Agenda
Village of Arlington Heights
Design Commission
Community Room, 3rd Floor
Arlington Heights Village Hall, 33 S. Arlington Heights Rd.
November 26, 2019
6:30 PM

STAFF DESIGN COMMISSION REPORT

Project Name: Kautz Residence
Project Address: 837 N. Pine Ave.
Prepared By: Steve Hautzinger

Requested Action(s): Approval of the proposed architectural design for a new (teardown) single-family residence.

ELEVATION STUDY MODEL (EXISTING)
837 N PINE

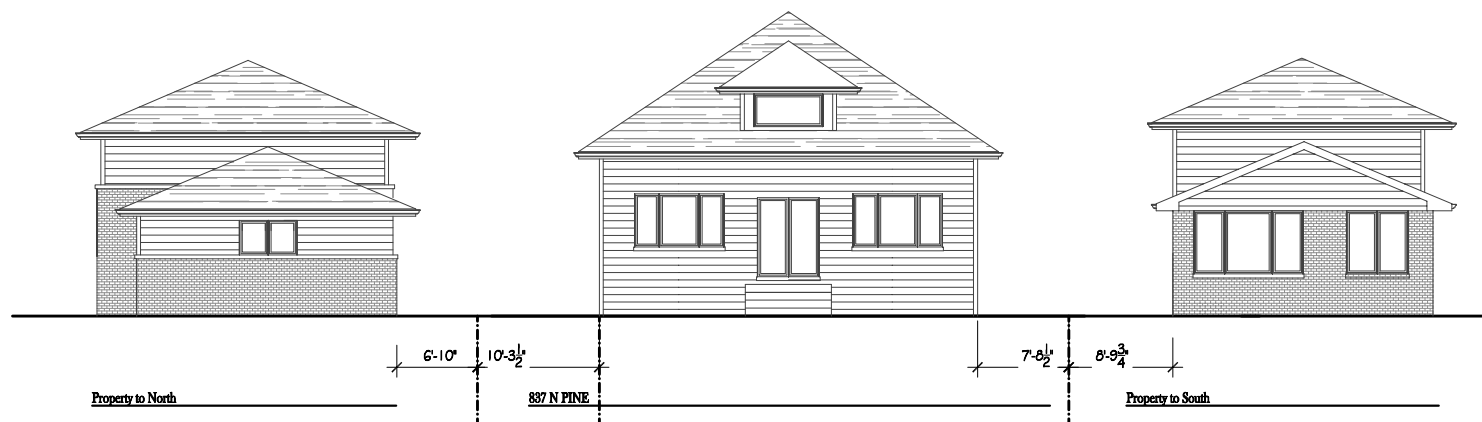
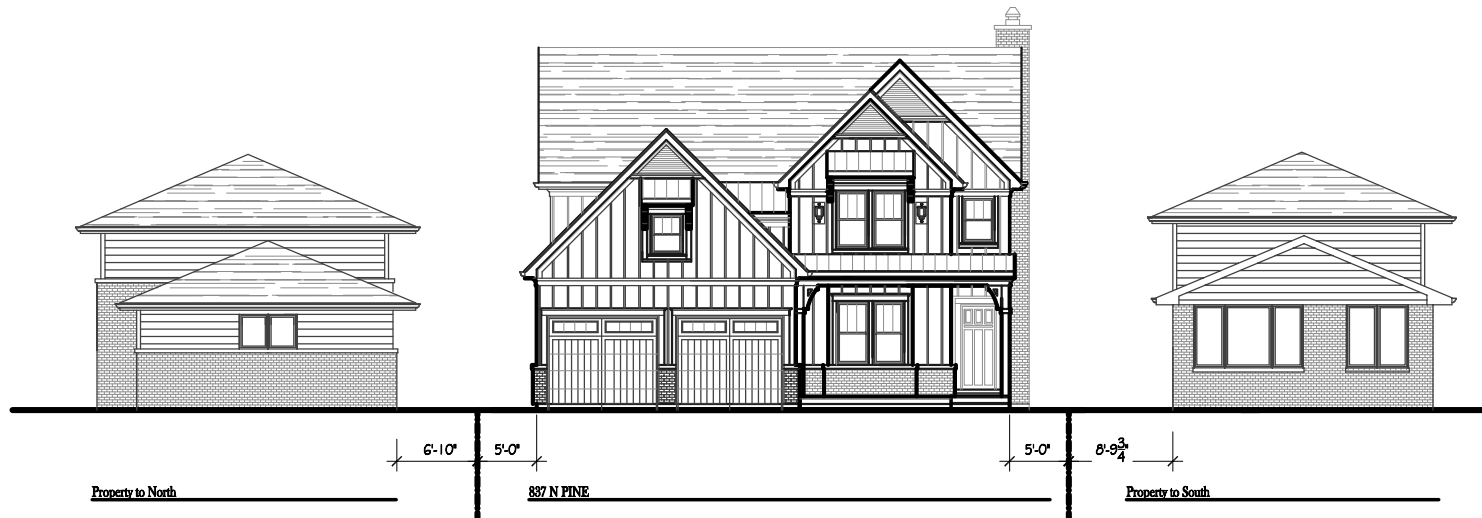
This neighborhood and this street have an eclectic mix of housing styles including older historic homes, mid-century split-levels, and newer two-story homes. There is a mix of attached and detached garages. Overall, the proposed house is nicely designed with a consistent level of detailing on all sides of the house. The proposed traditional style will generally fit well in this location, but the Design Commission should evaluate the scale of the proposed house between the two existing smaller scale split-level homes. The single-story garage and porch roofs do help to bring down the scale at the front of the house.

1. Evaluate the scale of the proposed house between the two existing smaller scale split-level homes.
2. This review deals with architectural design only and should not be construed to be an approval of, or to have any other impact on, any other zoning and/or land use issues or decisions that stem from zoning, building, signage or any other reviews. In addition to the normal technical review, permit drawings will be reviewed for consistency with the Design Commission and any other Commission or Board approval conditions. It is the architect/homeowner/builder's responsibility to comply with the Design Commission approval and ensure that building permit plans comply with all zoning code, building permit and signage requirements.
3. Compliance with all applicable Federal, State, and Village codes, regulations and policies.
